SAFETY EVALUATION BY THE OFFICE OF NUCLEAR REACTOR REGULATION
RELATED TO AMENDMENT NO. 229 TO FACILITY OPERATING LICENSE NO. DPR-28

ENTERGY NUCLEAR VERMONT YANKEE, LLC
AND ENTERGY NUCLEAR OPERATIONS, INC.
VERMONT YANKEE NUCLEAR POWER STATION

DOCKET NO. 50-271

Figure 2.8.7-24
Comparison of TGBLA-6 and CASMO-4 Coolant Void Reactivity Coefficients

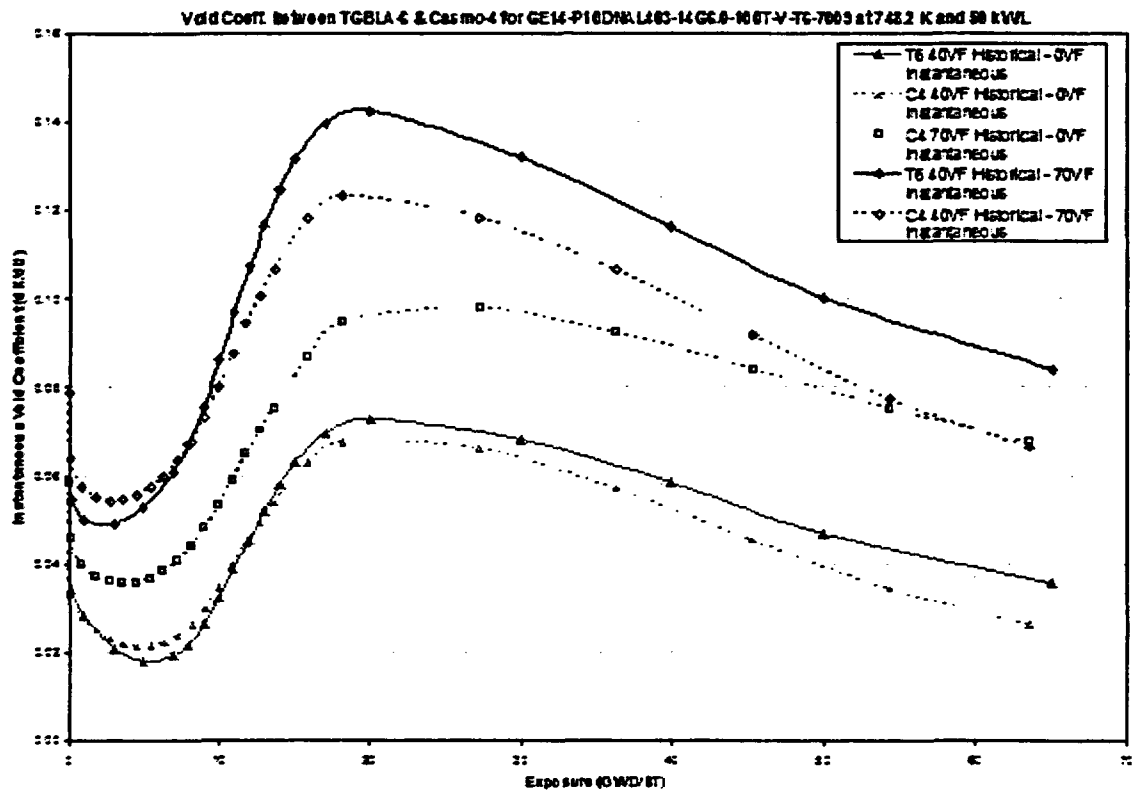
The void reactivity coefficient is an important parameter for predicting the transient response and stability of the reactor core. Comparisons of TGBLA-6 and CASMO-4 values of the void reactivity coefficient were compared in the RAI 66 response and are provided in Figure 2.8.7-24. The comparisons show that the agreement between the two codes is within the 15% assumed in the ODYN perturbation analysis. More significant is the large difference in the value of the void reactivity coefficient for the two different void histories used in the calculations (40% and 70%). The TGBLA/PANACEA neutronics methodology computes such instantaneous effects only for the 40% void history case. This assumption can lead to large errors in the evaluation of the void reactivity coefficient at high void fractions and high exposures. An evaluation of the impact of these errors was provided earlier.

Figure 2.8.7-25
Comparison of TBGLA-6 and CASMO-4 Pu-239 Composition for Lattice 6996

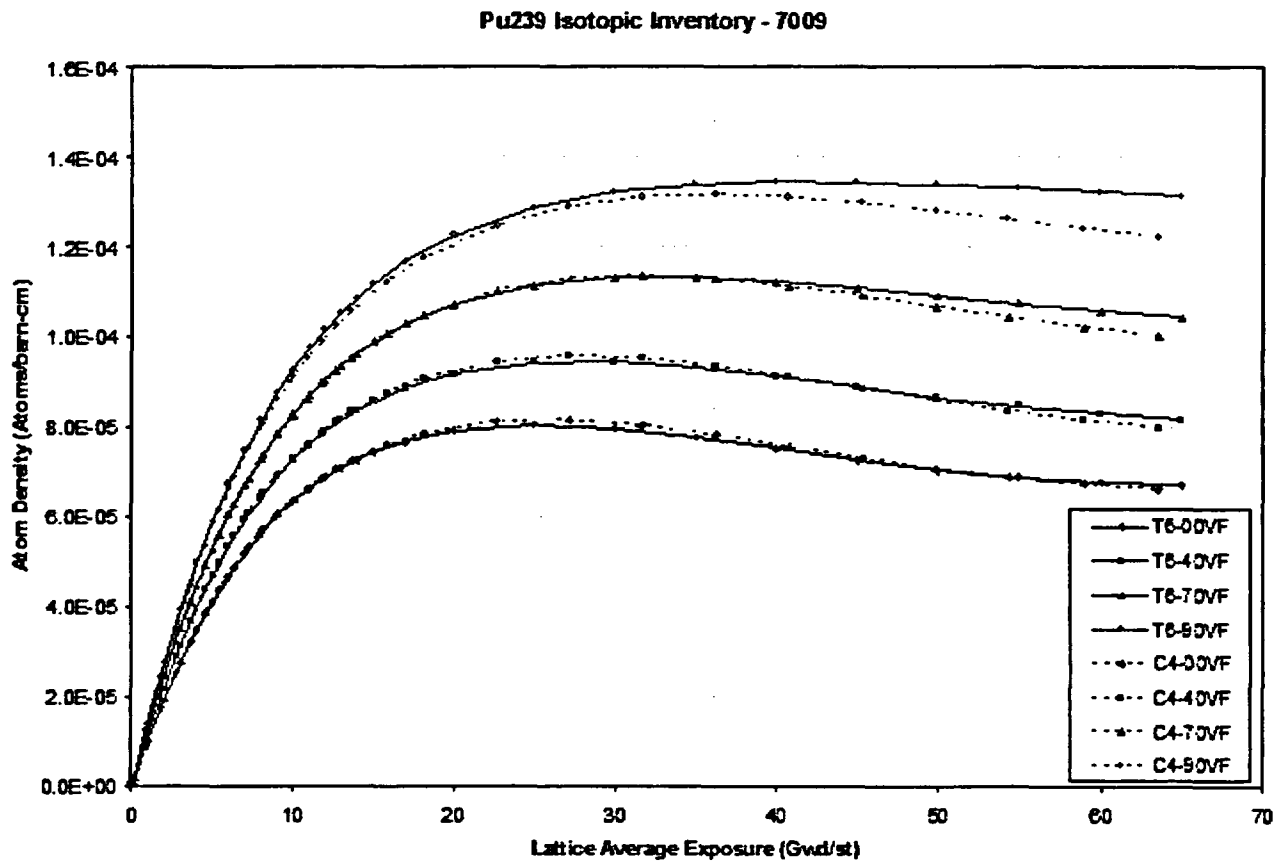
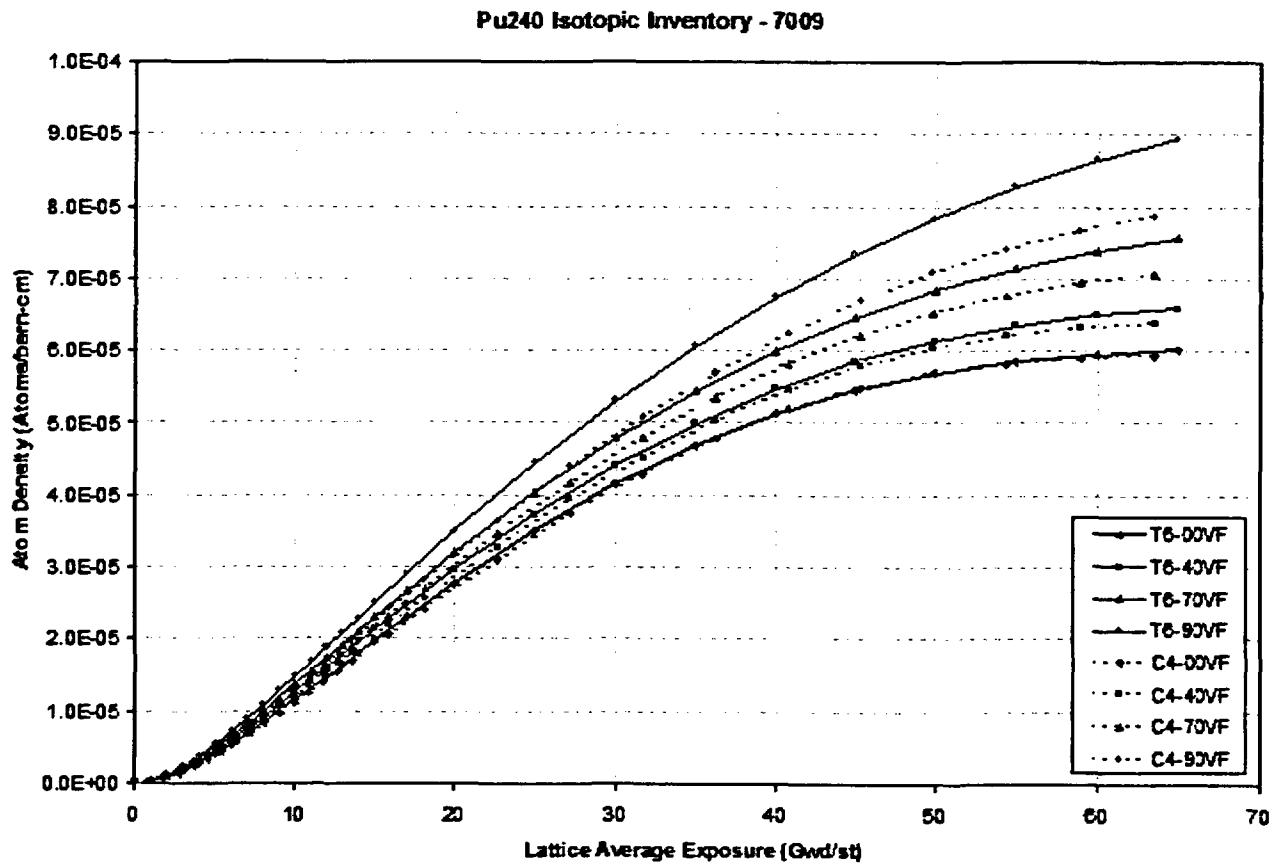
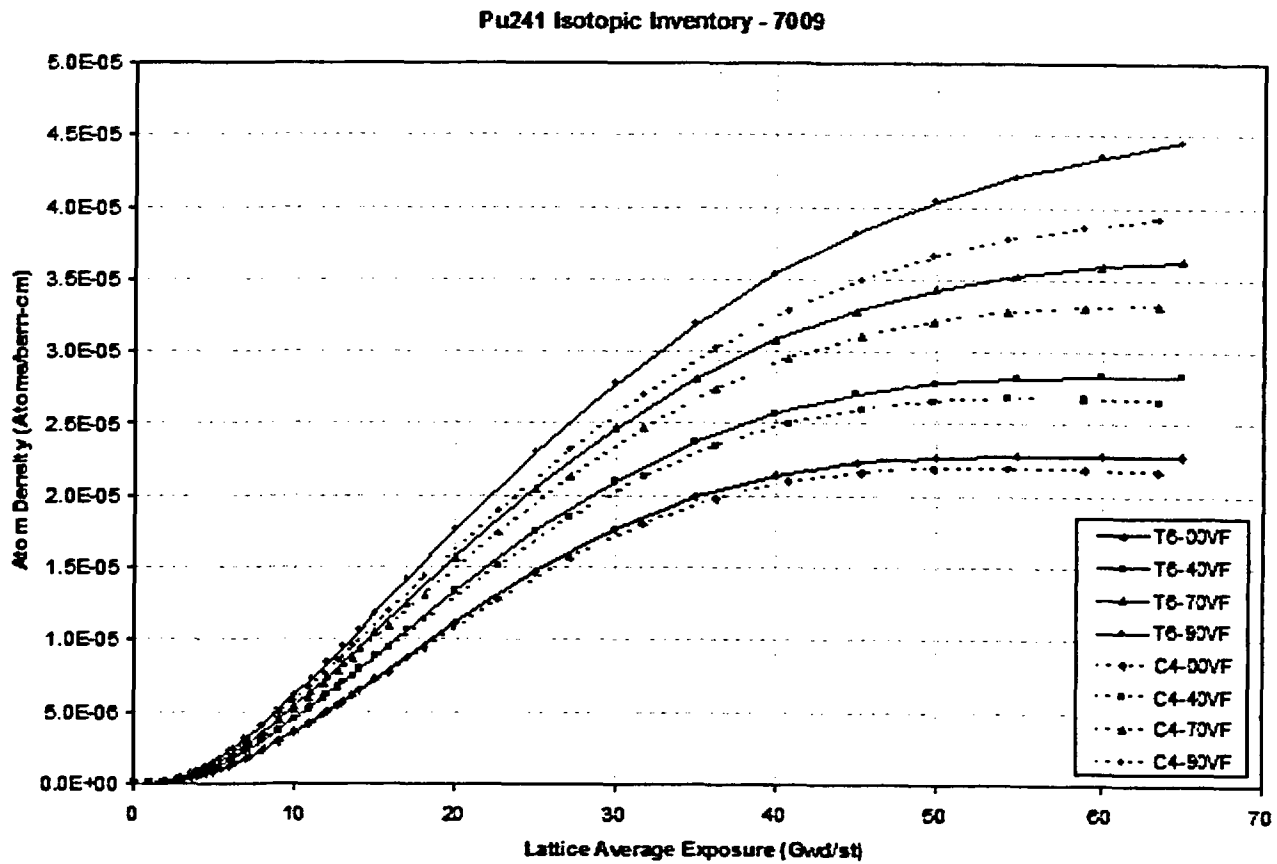
The plutonium compositions were compared between the two codes as an indication of the prediction of the neutron spectrum and as a further investigation of potential impacts on the void reactivity coefficient and SDM. The comparison of the Pu-239, Pu-240 and Pu-241 isotopic compositions (Figures 2.8.7-25 to 27) show very good agreement, particularly at the lower void fractions. Notably, Pu-239, the primary fissile plutonium species present, has very close agreement between the two codes.

Figure 2.8.7-28
Change in Pin Power Distribution Between 0% and 30% Bypass and Water Rod Voiding

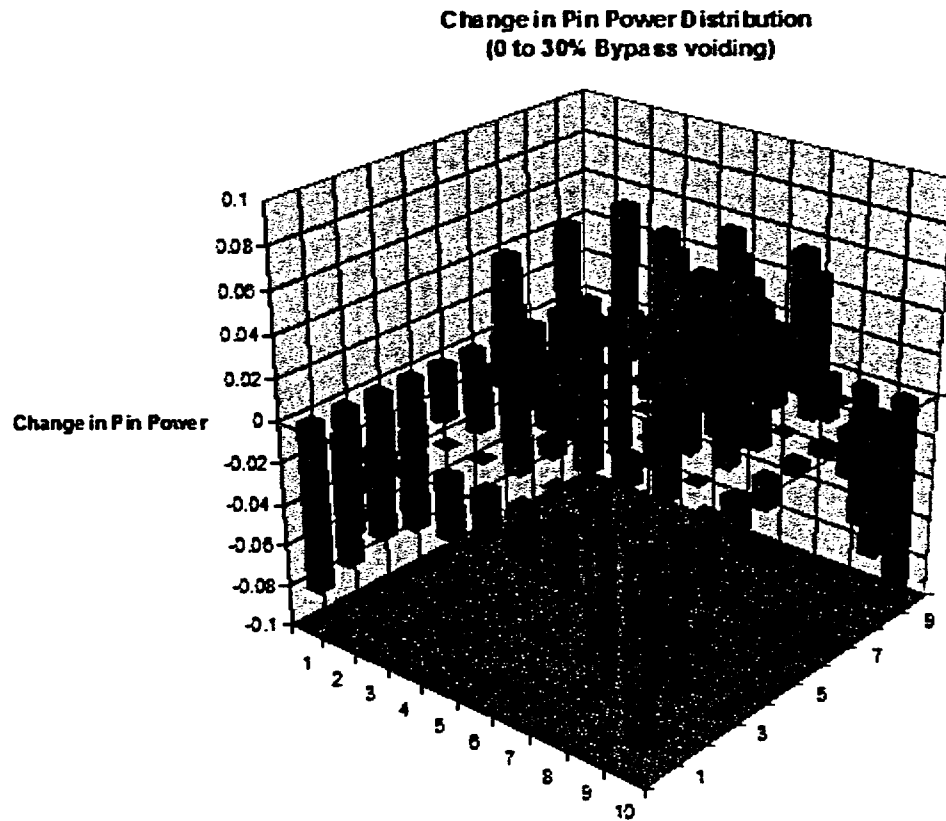
The results indicate that the power generation in the bundle is shifted away from the bypass region to the interior region of the bundle as voiding occurs. This is clearly demonstrated by plotting a difference of the power distribution between the 0% and 30% voiding cases, as is shown in Figure 2.8.7-28. The largest reduction in the pin power occurs in the corner pins, which have two faces adjacent to the bypass region. This results in a reduction of the power peaking factor since the peak pin is located near the bypass region. The reduction in the RMS of the pin power difference from the unity results presented in Table 2.8.7-3 show that the power profile becomes more uniform ("flatter") as the bypass region voids (an RMS of zero would indicate a flat power profile, while a large value indicates a high-degree of peaking). The results also show that the relative power of the peak pin also decreases (the peak does remain in the same pin for all bypass void conditions). The reduction in the lattice Kinf value indicates
